MERCURY service bulletin *MerCruiser*

No. 2000-6

▲ = Revised May 2000. This bulletin supercedes the previous bulletin 2000-6.

Official Notification Federal Boat Safety Act - Commander 3000 Classic Remote Control Decal

a - Date Code

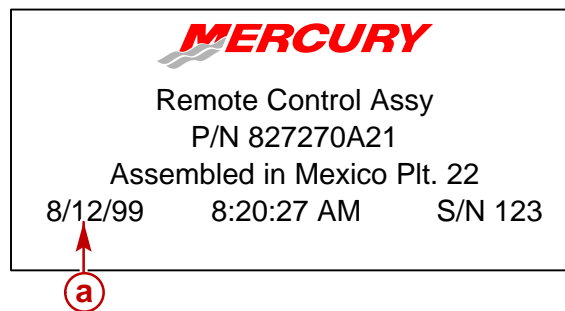
Box date code 8/12/99 (August 12, 1999) through 9/29/99 (September 29, 1999).

Incorrect Starboard Mount Decal

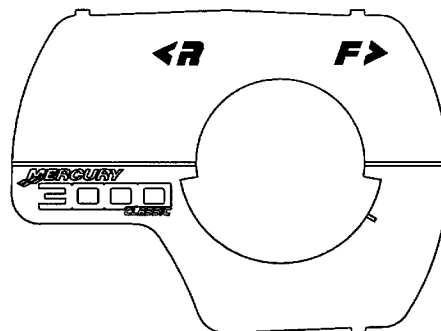
▲A quantity of Commander 3000 Classic Panel Mount Remote Controls with box date code listed were shipped with an incorrect bezel decal. The incorrect decal has the "R" (indicating REVERSE) printed to the front and the "F" (indicating FORWARD) printed to the rear of the bezel decal when the control is starboard mounted. For starboard remote control mounting, a new Mercury P/N 37-827289--4 bezel decal must be installed.

▲ Inspect for an incorrect decal that has the “R” printed to the front and the “F” printed to the rear of the bezel decal when the remote control is starboard mounted.

Correct Starboard Mount Decal

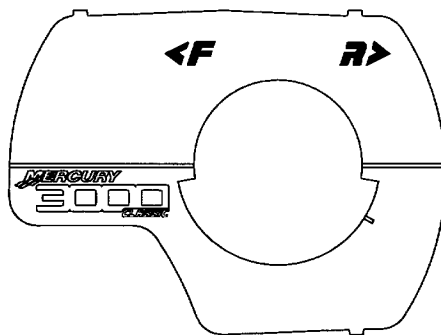
▲ Replace the incorrect bezel decal. Partial disassembly of the remote control is required. Refer to the Remote Control Service Manual 90-814705R2 SECTION 11.

Qty. 1 P/N 37-827289--4 Mercury decal.
